I live near Clement Ave and I recently reviewed the "Final Design 30 percent drawings" for the Clement Avenue Redesign project. I believe the plan represents an important step toward improving safety for all road users and providing an essential link in the Cross-Alameda bicycle trail.

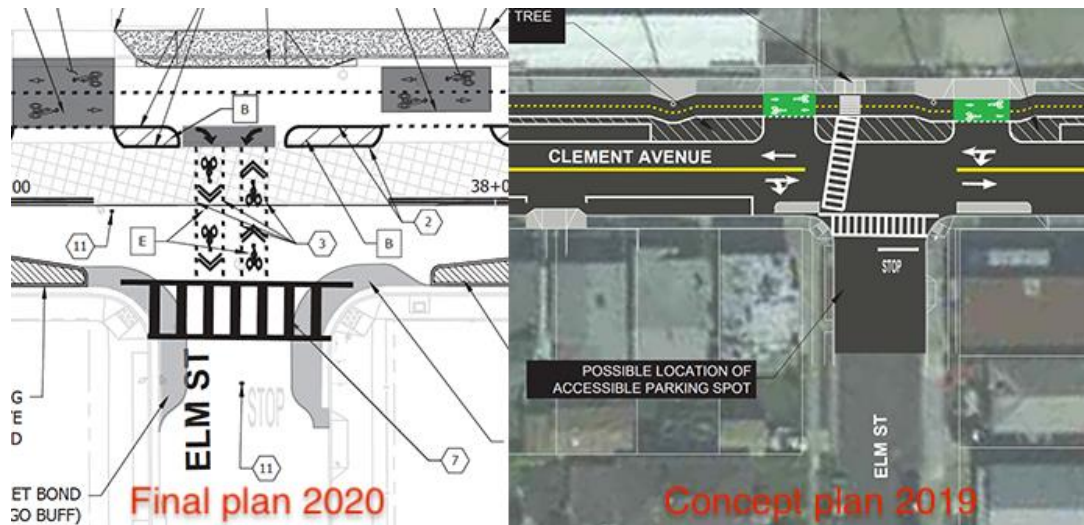
I was disappointed to see that the crosswalk marking at Elm St from the concept plan has been eliminated and I would like to see it restored:

The notable scarcity of markings at legal crosswalks around Alameda is one of the main reasons why its streets are often less hospitable to pedestrians than those of nearby cities like Berkeley and Oakland. I believe Alameda should not miss any opportunity such as this to mark an existing legal crosswalk.

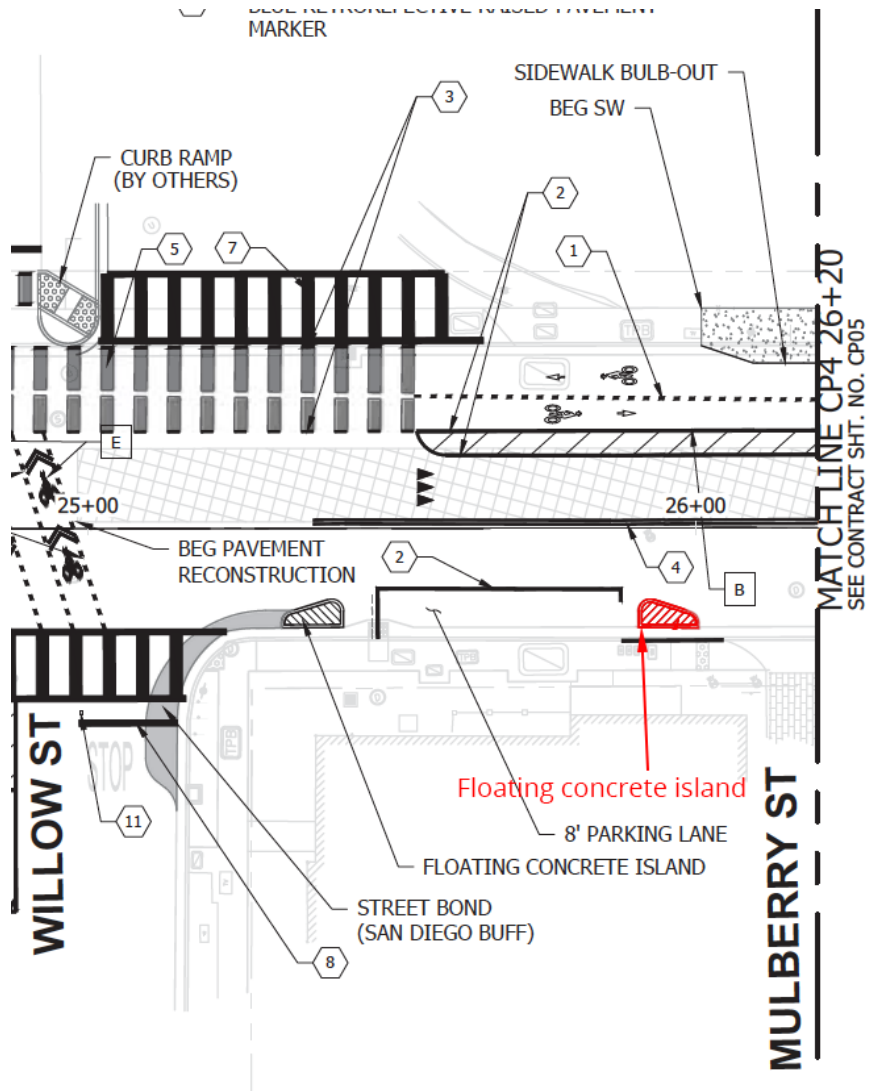
I also like the floating concrete islands which serve to daylight intersections, as physical infrastructure is preferable to relying on enforcement. I would very much like to see a similar island—or a sidewalk bulb-out—installed just west of the intersection with Mulberry St. Although that section of curb is already marked as a no-parking zone, drivers frequently park there anyway, impeding visibility for anyone turning onto Clement from Mulberry:
